<b>High Level Review of the Mt Pleasant Operation Mine Optimisation Modification Environmental Assessment May 2017</b>	
<b>Date:</b>	2 July 2018
<b>To:</b>	The President of the Hunter Thoroughbred Breeders Association
<b>From:</b>	Rod Carr, Director at Marsden Jacob Associates

Marsden Jacob Associates, one of Australia's leading independent economic and financial advisory firms, has undertaken an expert review of the economic analysis of the Mt Pleasant Operation Mine Optimisation Modification Environmental Assessment.

Peter Stephenson, Managing Director of Stephenson Environmental Management Australia (SEMA) (CV attached as Appendix C) was requested by the Hunter Thoroughbred Breeders Association (HTBA) to undertake a review and critique of the air quality matters referred to in the assessment of the proposal conducted by the NSW Department of Planning and Environment in the Independent Planning Commission of New South Wales Proceedings No. D512/18 regarding the Mount Pleasant Operation Coal Mine Extension of Mine Life.

## **Review of the Mt Pleasant Operation MOD3 Mine Optimisation Modification**

**APPENDIX A – AMBIENT AIR QUALITY MONITORING - PARTICULATE MATTER  
CONCENTRATIONS 2015 - 2017**

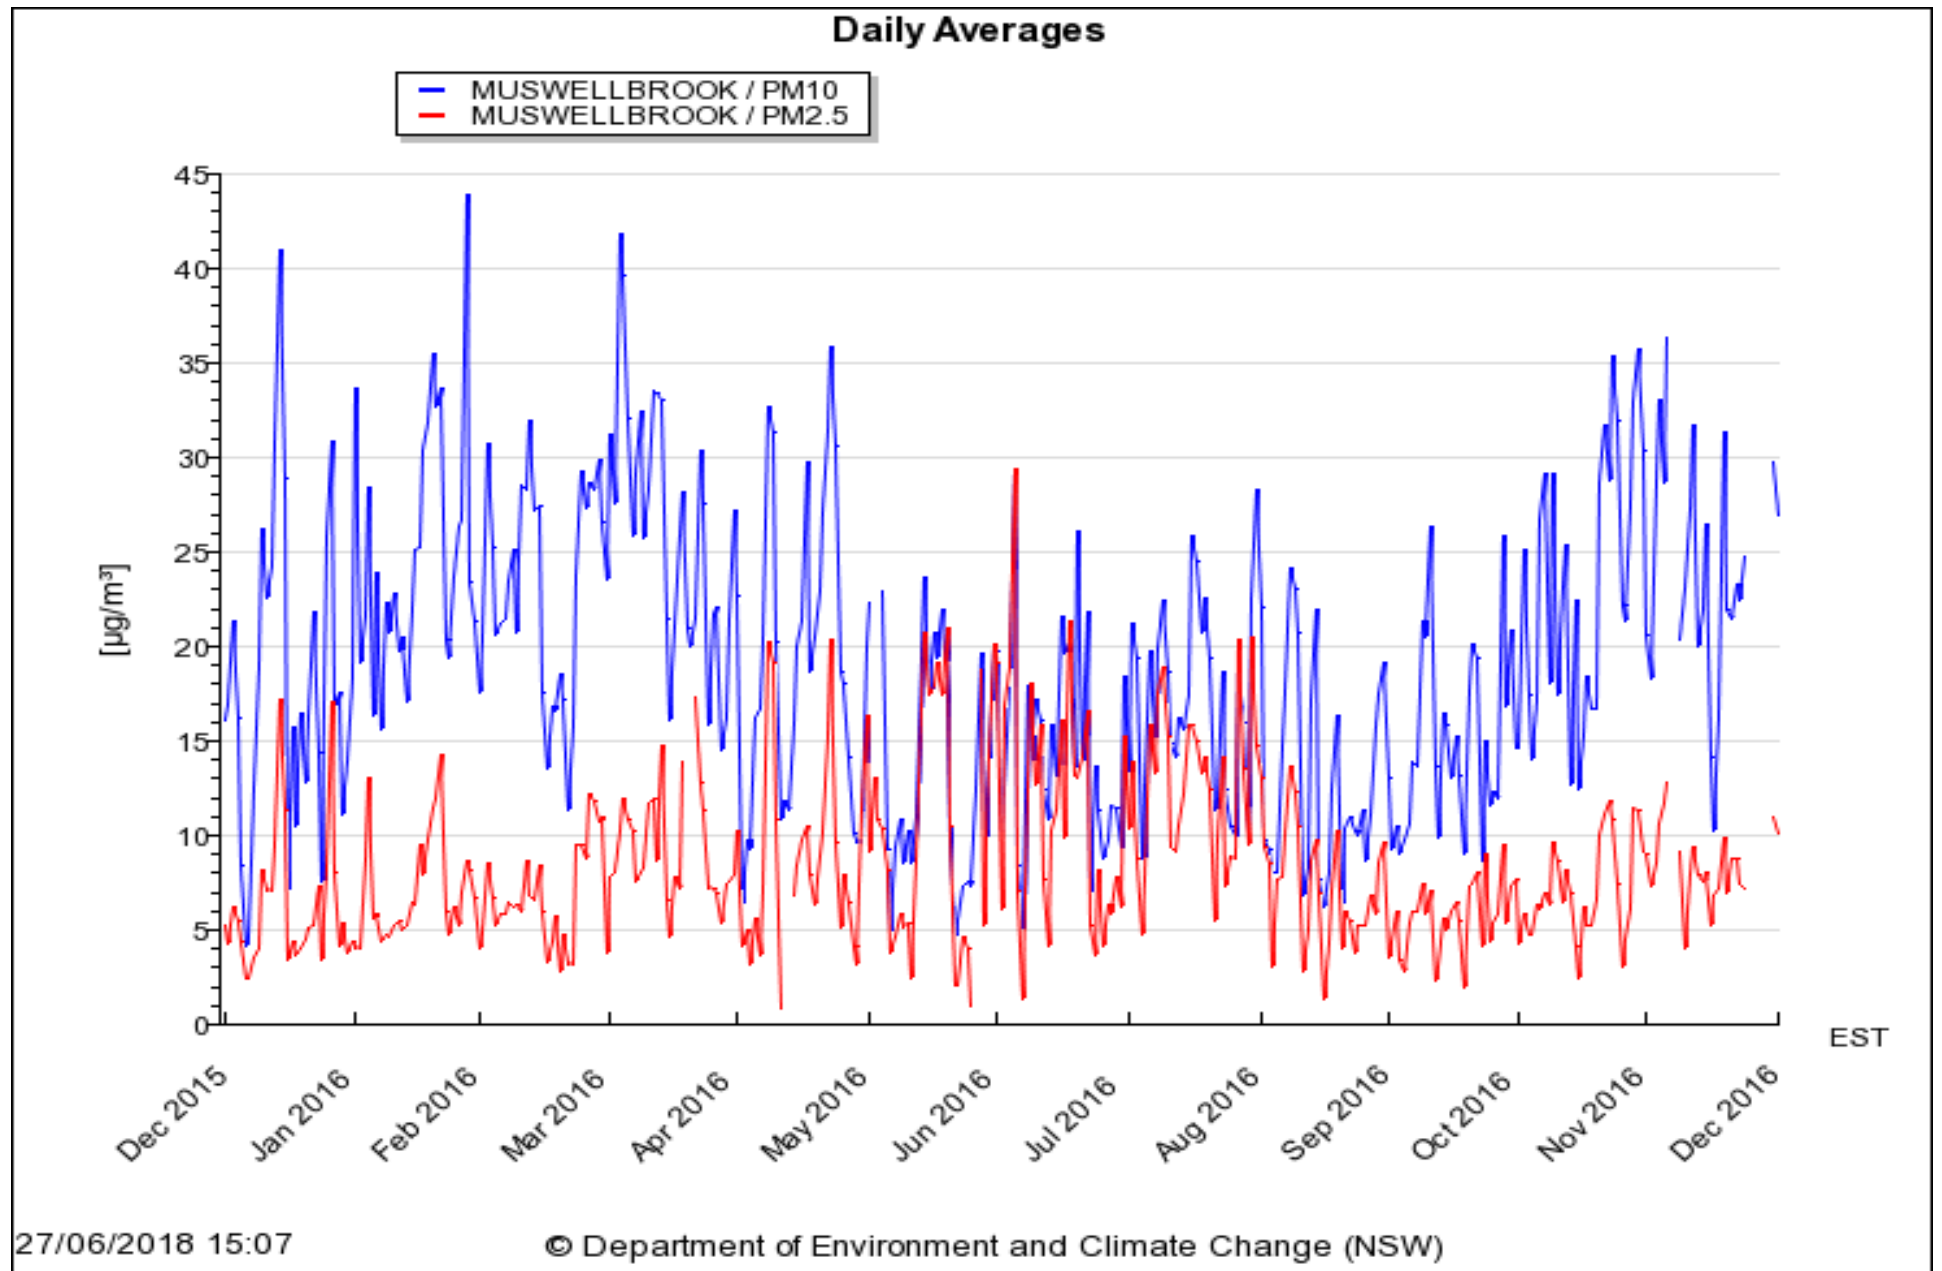
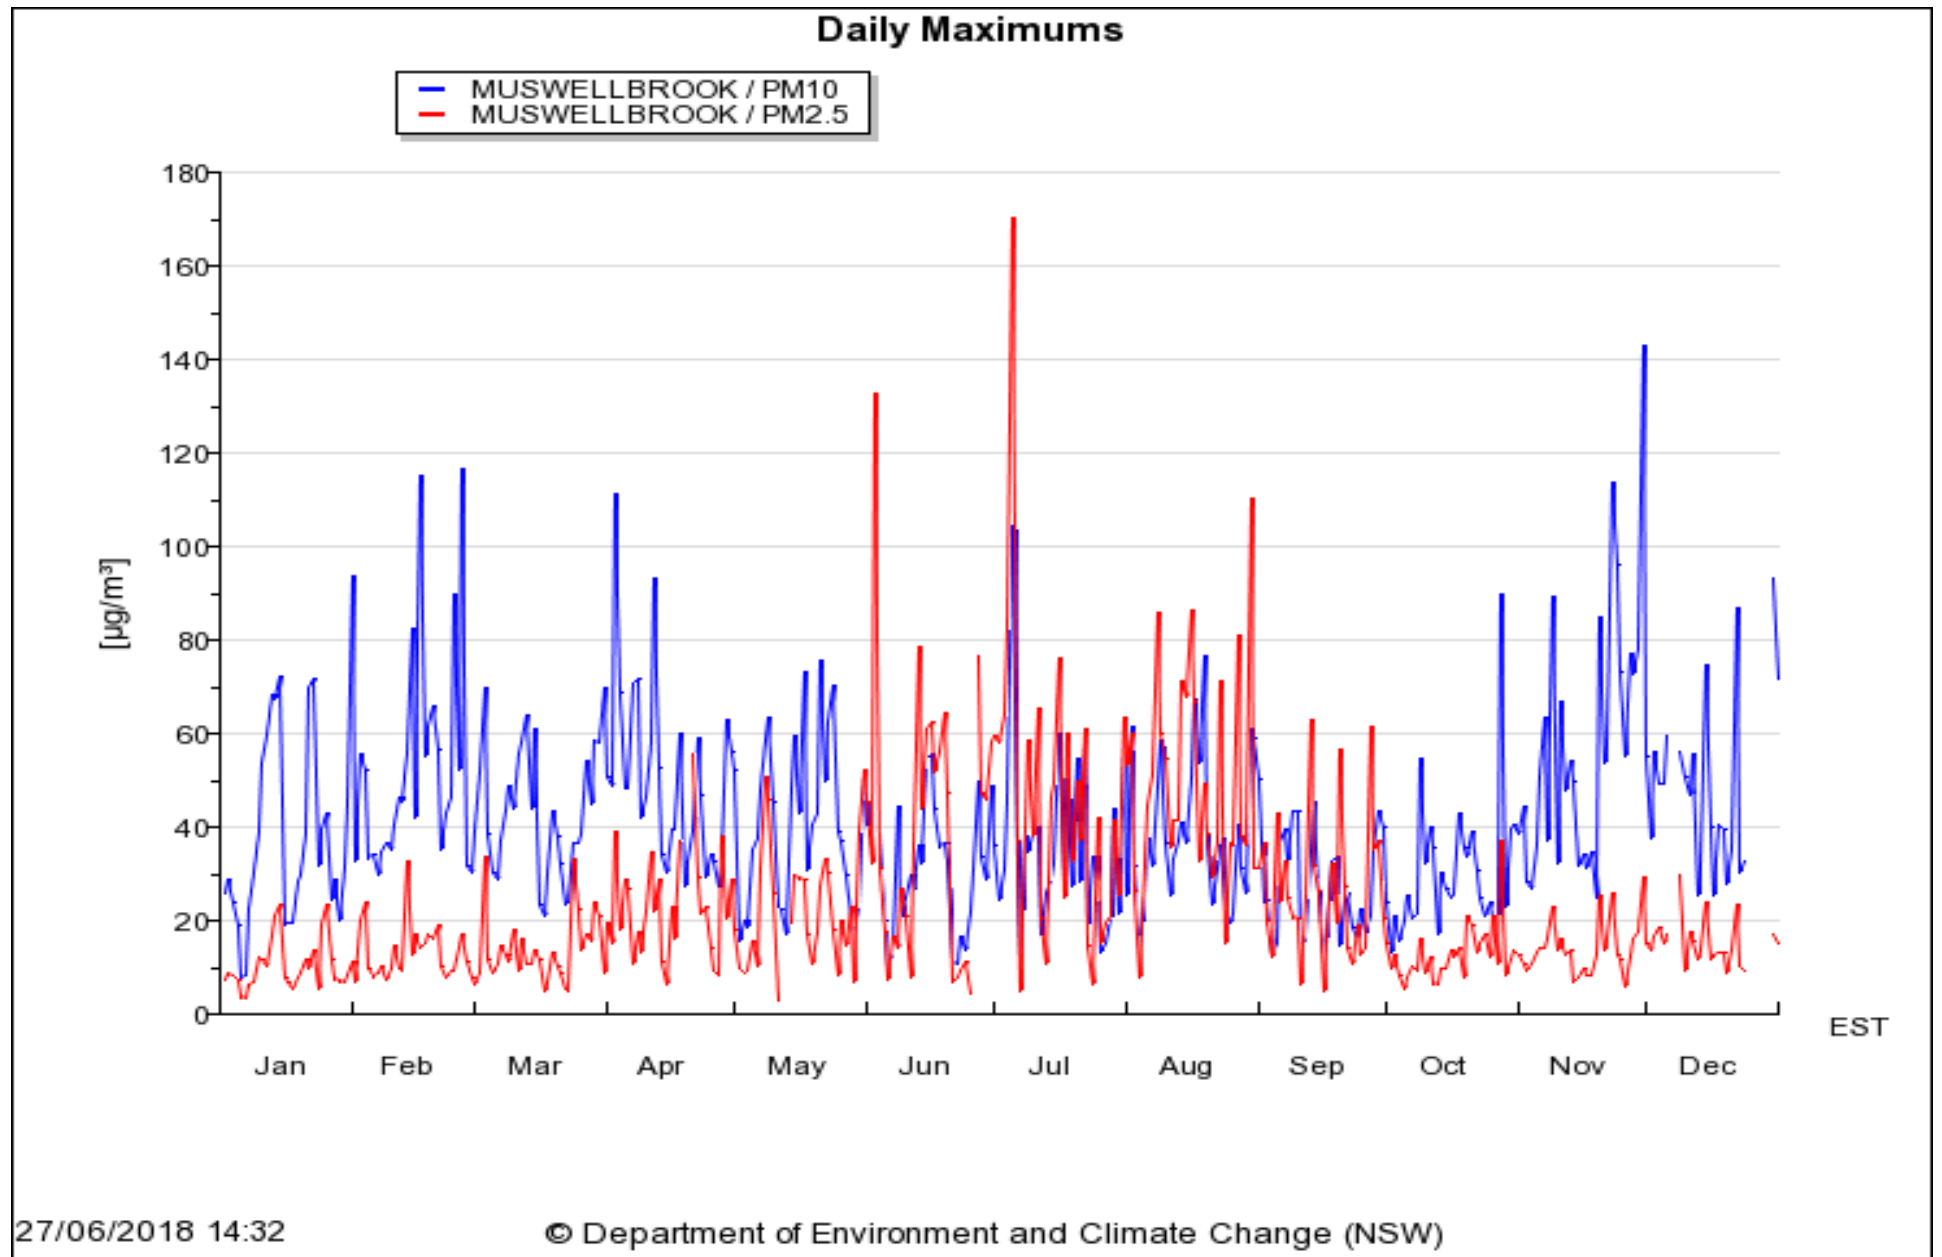
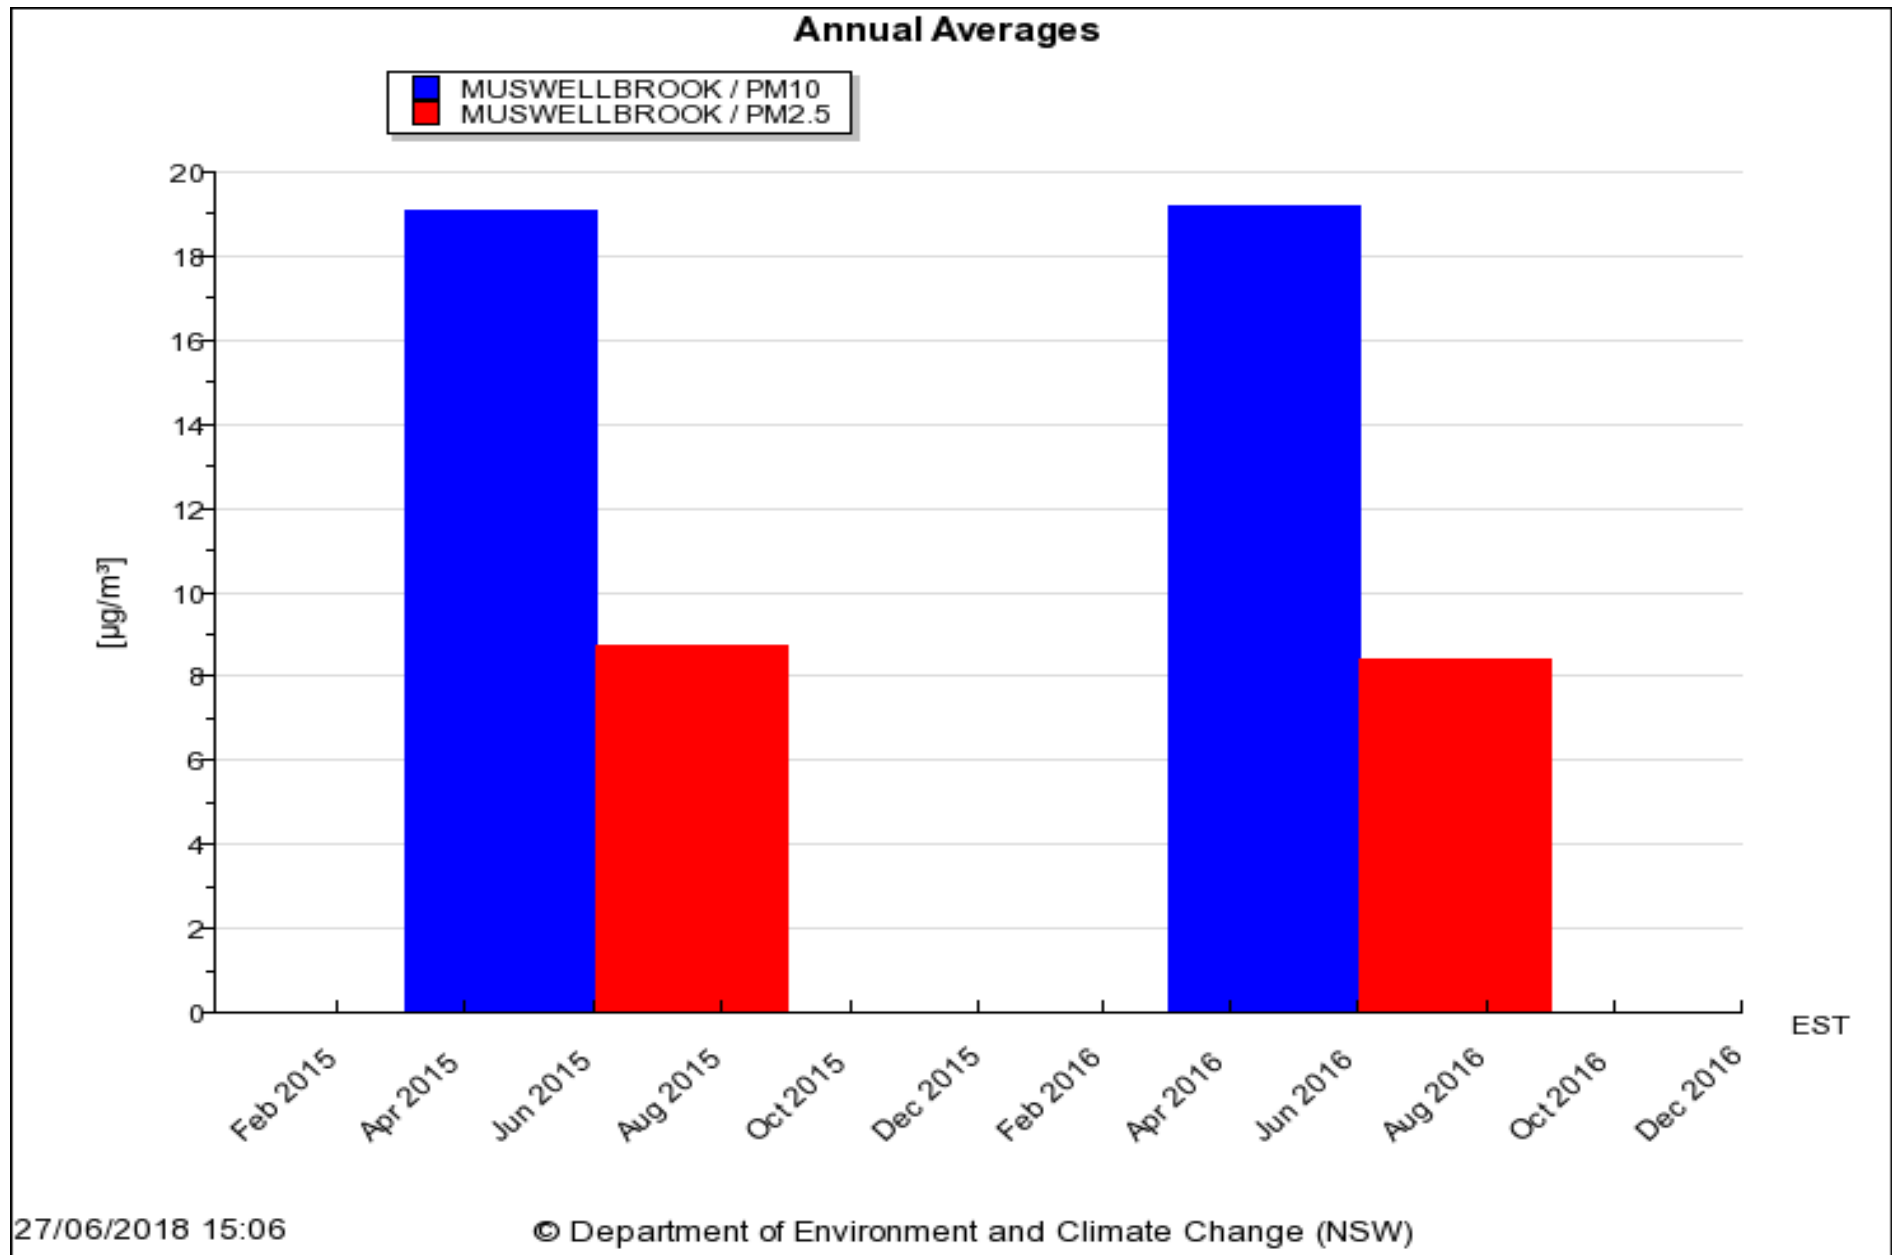
*Furthermore, the plots of data presented in Appendix A of this assessment report show regular exceedances for most of the year. This diminished air quality is the product of previous Planning NSW decisions and further development without radical rework of the mines emission controls will further diminish local air quality.*
